FINAL Environmental Impact Statement Newmont Mining Corporation's South Operations Area Project Amendment

Appendix E Public Comment Letters and Responses

RESPONSES TO PUBLIC COMMENTS ON SOAPA DEIS

Figure 28. Drawdown in layer 1 for the original scenario and three gravel in clay layer scenarios.

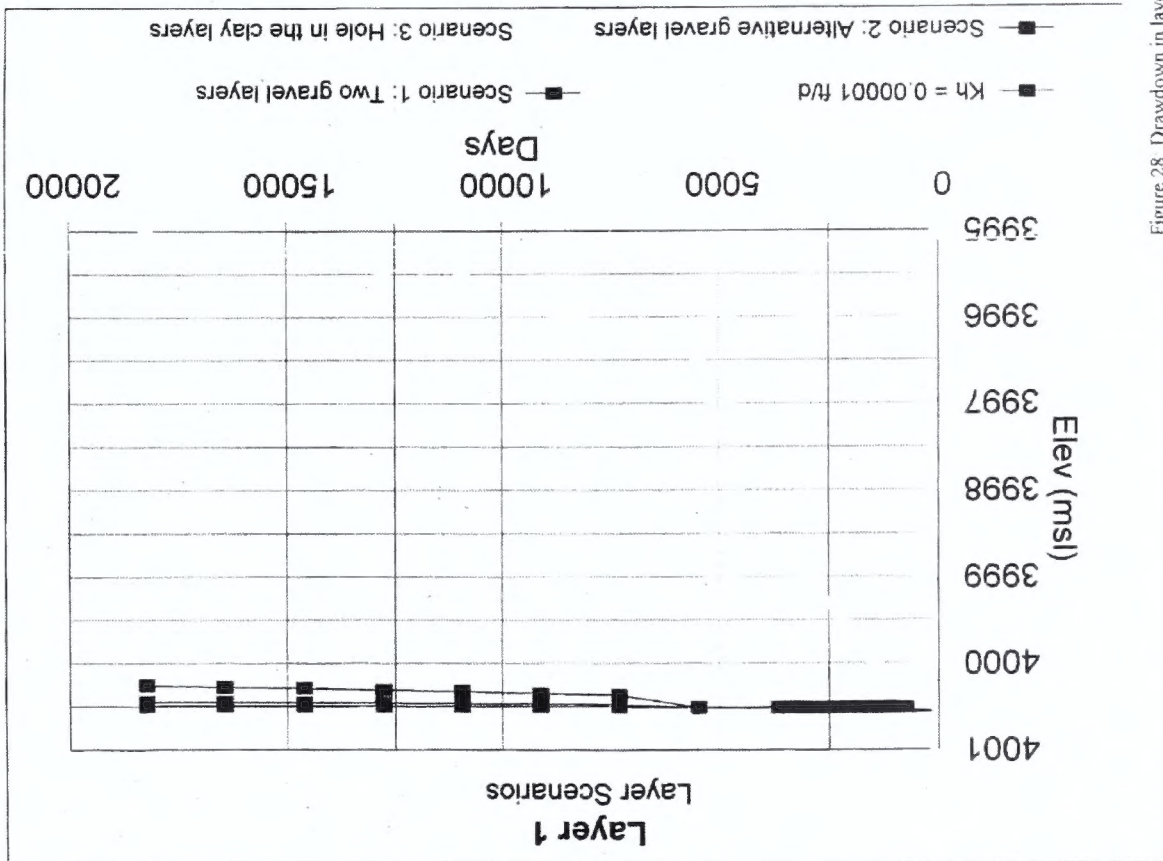
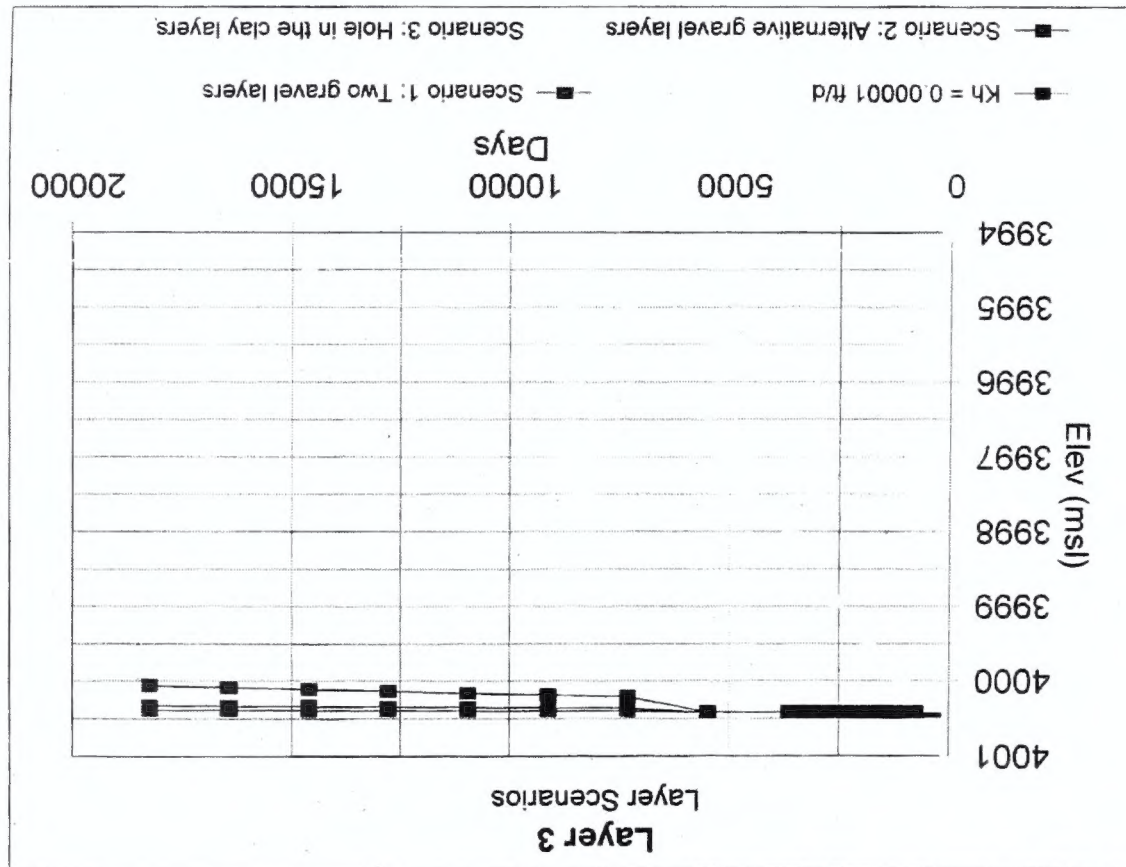
The river flux changes reflect the head changes in layers 1 and 3 (Figures 28 and 29). There was little change from the original caused by adding gravel layers to the clay layer, but the hole allowed the head to drop more than 4 feet. This caused the gradient reversal near the river to change. The head change resembled the effects caused by increasing the hydraulic gradient to $6 \times$ to $10 \times$ Kh in the first sensitivity analysis (Figures 14 and 15).

Figure 30: Drawdown in layer 4 for the original scenario and three gravel in clay layer scenarios

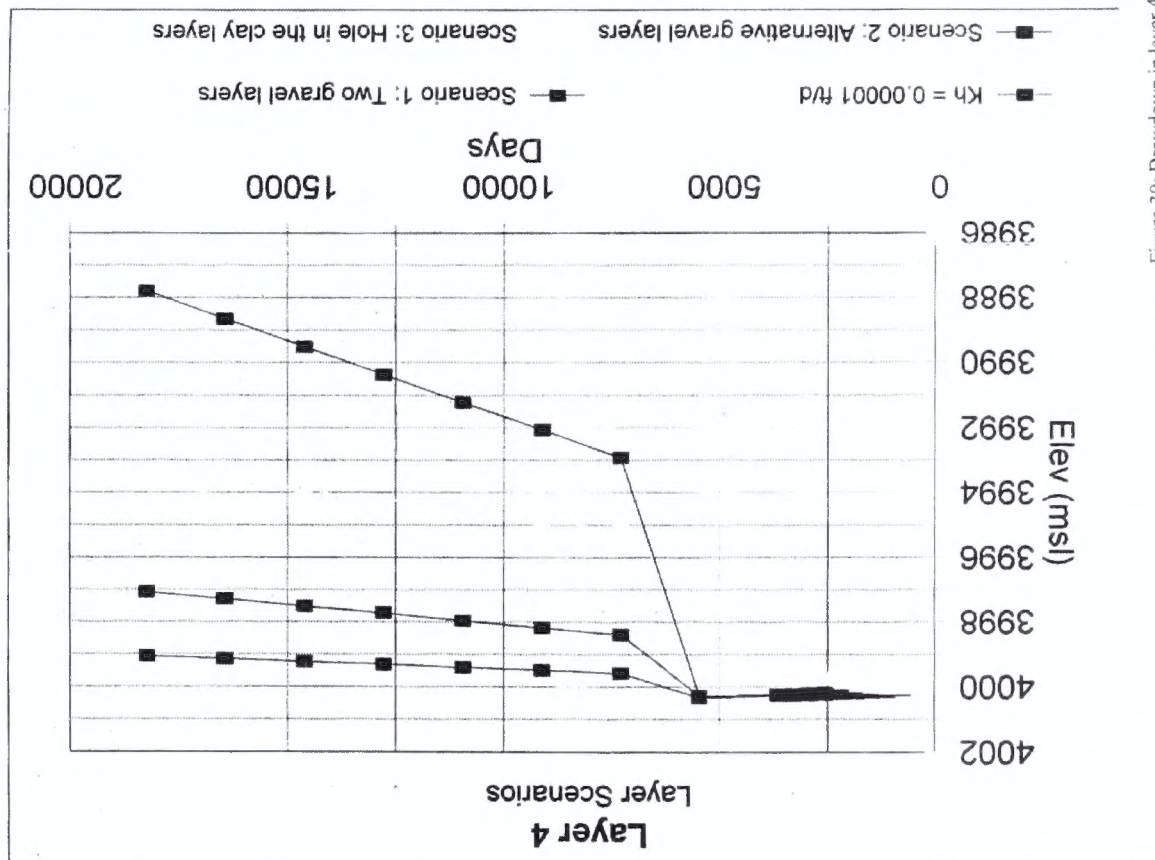
As in the sensitivity analyses changing the clay conductivity, Scenario 3 caused decreased drawdown in the various layers. In layer 4, the drawdown at the target was less than for Scenario 2 (Figure 30). In layers 10 and 14, the Scenario 3 drawdown was even less than for Scenarios 1 and 2. As it becomes easier for water to move through the clay layer, the drawdown due to the mine becomes less.

Figure 34. Groundwater contours for layer 15 for scenario 3 after 61 years

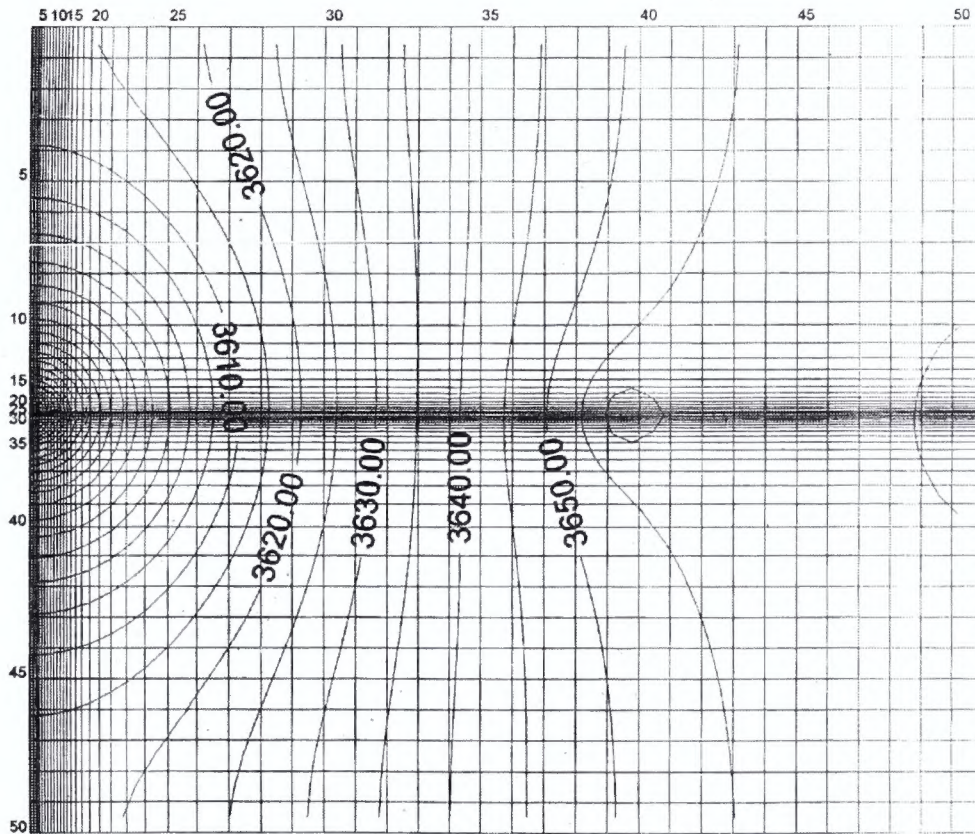
In layer 15 just after the maximum drawdown is reached, contours indicate a relative gradient from 3660 at the hole to 2900 near the GHB (Figure 34). A divide forms between the hole and GHB in layer 14 (Figure 35). Water drains through the layers near the GHB, but more flows through the hole. In layer 14, flow through the hole is 56,400 ft³/d, while flow through the top of the layer is 80300 and through the bottom is 138,000 ft³/d. The difference is due to a 57000 ft³/d release from storage. By layer 13, a slight gradient to the GHB still exists, but the hole causes a massive drawdown (Figure 36). Flow through the hole is 56400 ft³/d while through the top of the layer flow is 61,900 ft³/d and 80,300 ft³/d through the bottom of the layer. Flow through the upper layers and the hole are equal at 56,400 ft³/d.

Figure 1: Pit lake inflow by layer for the scenario without mitigation.

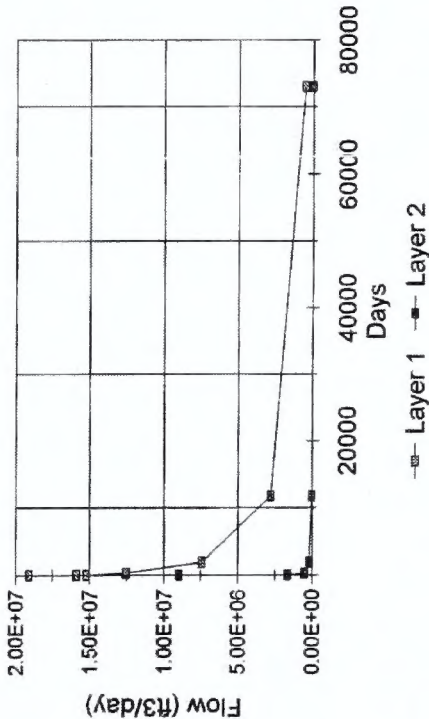
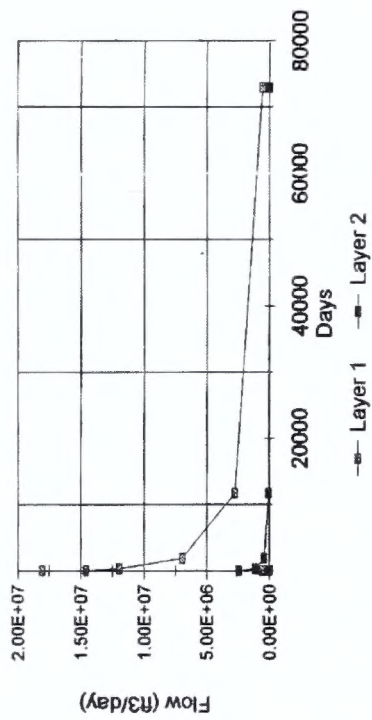
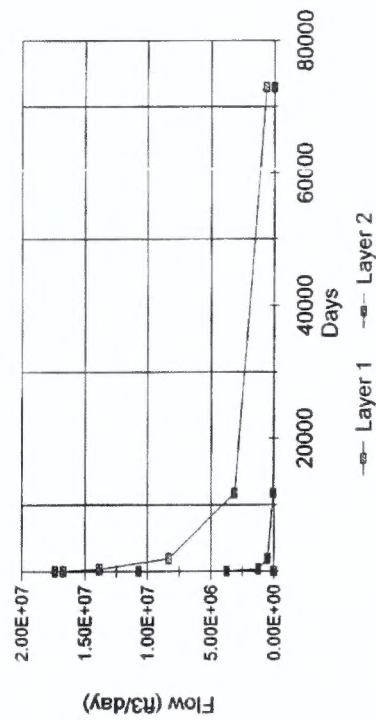
Figures 1 through 3 show the rate of pit lake inflow by layer. Without mitigation, most of the flow returns from layer 1 even though the pumpage from 1998 through 2011 removed equal amounts from each layer. A probable reason is that the storage coefficient is specific yield; the pressure in the lower layers causes a vertical flow upward into layer 1. During the first year, upward flow was 7811828 ft³/d for the no mitigation alternative and 6630252 during the steady state analysis. The steady state rate is high because the primary discharge from the steady state model is to ET; the additional 9901 afy is to the pit lake. Injection increased the flow from layer 2 into the pit lake, but it was not substantial (Figure 2). Infiltration increased the rate to the pit from layer 1 by about 20% (Figure 3). Total pit inflow is 95, 85, and 96% from the top layer for the without mitigation, injection, and infiltration alternatives.

Figure 4. Flux to various streams during recovery for the without mitigation scenario.

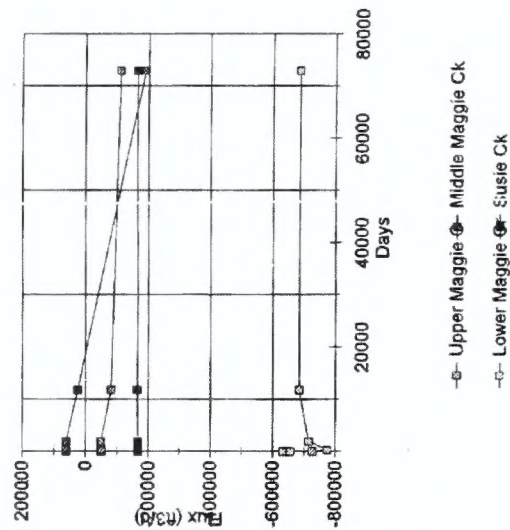
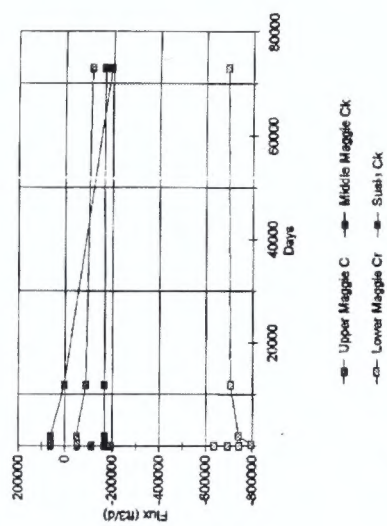
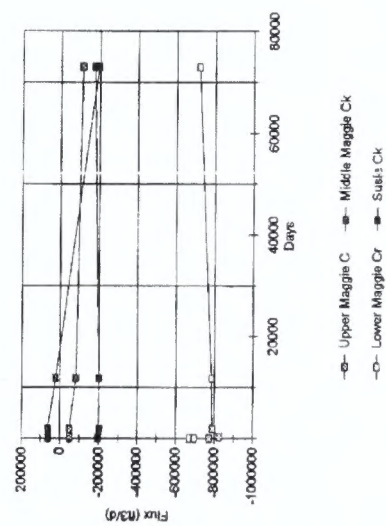
Lower Maggie Creek has an approximate 5% increase in flux to it over the long term.

Susie Creek has only slight improvements. With infiltration, fluxes increase faster, although on Maggie Creek the ultimate rate is approximately the same. The biggest change is on Susie Creek which almost immediately increases by 0.2 cfs.
